PROJECT TITLE:
NEIGHBORHOOD
11 OCTOBER 2016
ILLUSTRATIVE SITE PLAN

PETITION NO.: Z-98

Z-98 Revision #2

Z-98 SHOWCASE REAL ESTATE DEVELOPMENT, LLC

SP-3

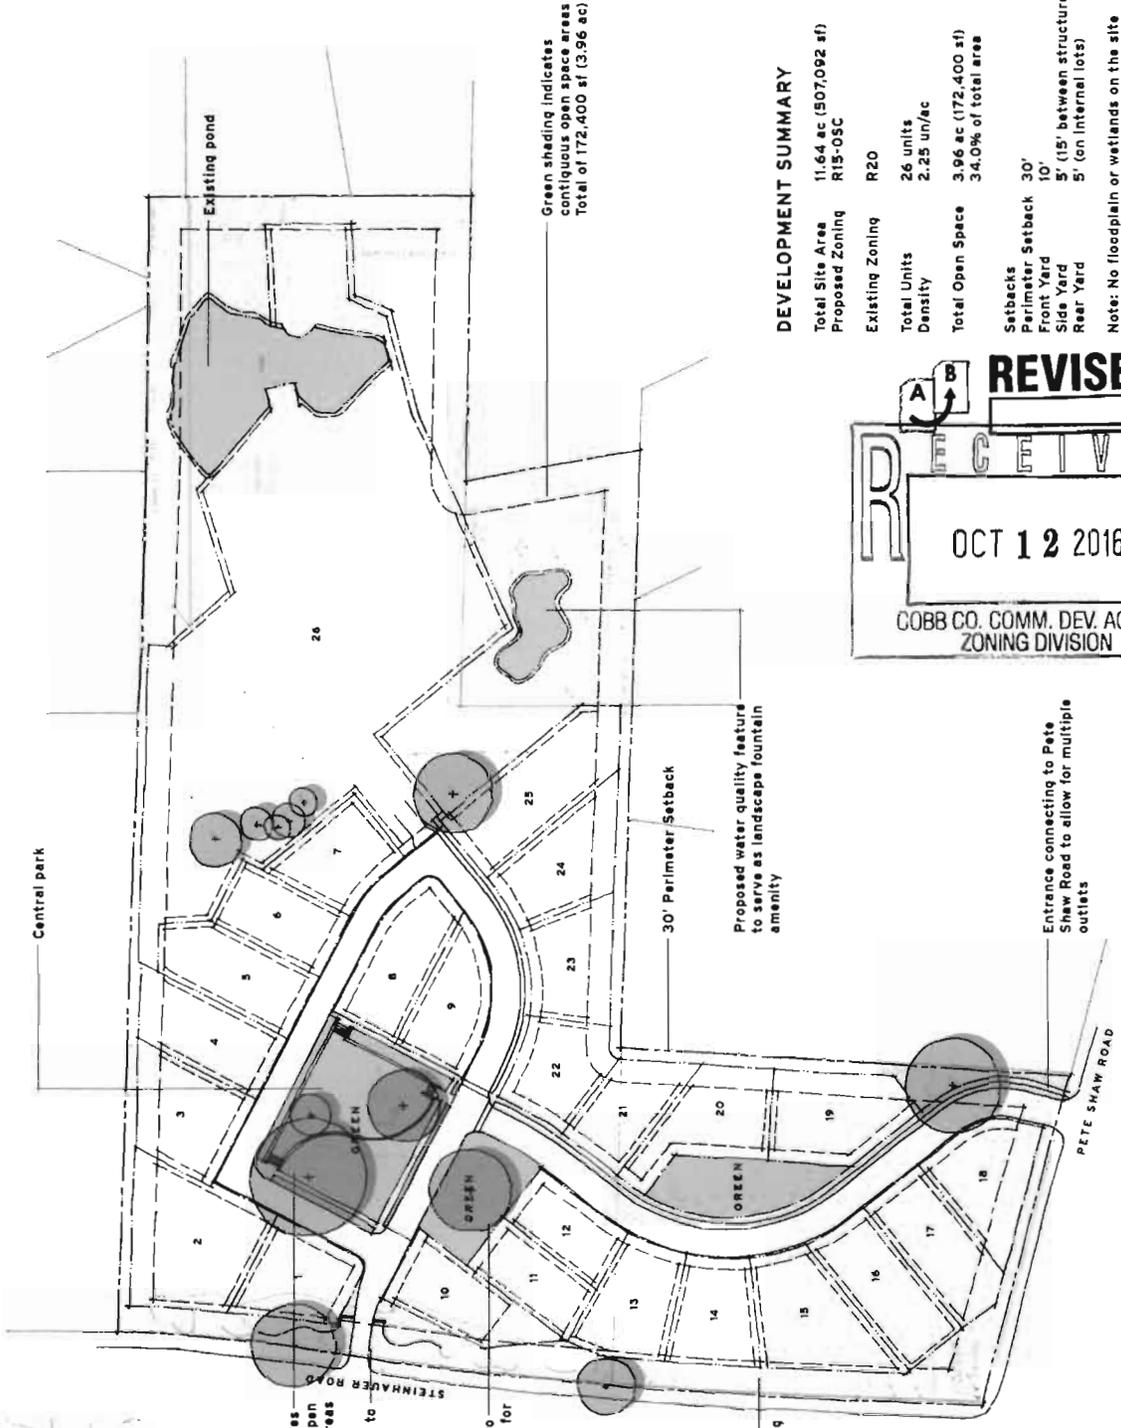
Additional Comments: Relocation of existing sewer may be necessary, depending on final lot layout.

- Provide comprehensive hydrology/stormwater controls to include development of out parcels.
- Submit all proposed site improvements to Plan Review.
- Any **spring activity** uncovered must be addressed by a qualified geotechnical engineer (PE).
- Structural fill must be placed under the direction of a qualified registered Georgia geotechnical engineer (PE).
- Existing facility.
- Project must comply with the Water Quality requirements of the CWA-NPDES-NPS Permit and County Water Quality Ordinance.
- Water Quality/Quantity contributions of the existing lake/pond on site must be continued as baseline conditions into proposed project.
- Calculate and provide % impervious of project site.
- Revisit design; reduce pavement area to reduce runoff and pollution.

- No Stormwater controls shown _____
- Copy of survey is not current – Additional comments may be forthcoming when current site conditions are exposed.
- No site improvements showing on exhibit.

Recommend curb and gutter along both sides and sidewalk along one side of proposed development roadway.

Recommend entrance on Pete Shaw Road be a minimum of 250 feet from the intersection of Steinhauer Road.

1. Site plan received by the Zoning Division October 12, 2016, with the District Commissioner approving minor modifications;
2. Planning Division comments;
3. Fire Department comments and recommendations;
4. Water and Sewer Division comments and recommendations;
5. Stormwater Management Division comments and recommendations;
6. Department of Transportation comments and recommendations; and
7. Owner/developer to enter into a Development Agreement pursuant to O.C.G.A. §36-71-13 for dedication of system improvements to mitigate traffic concerns.
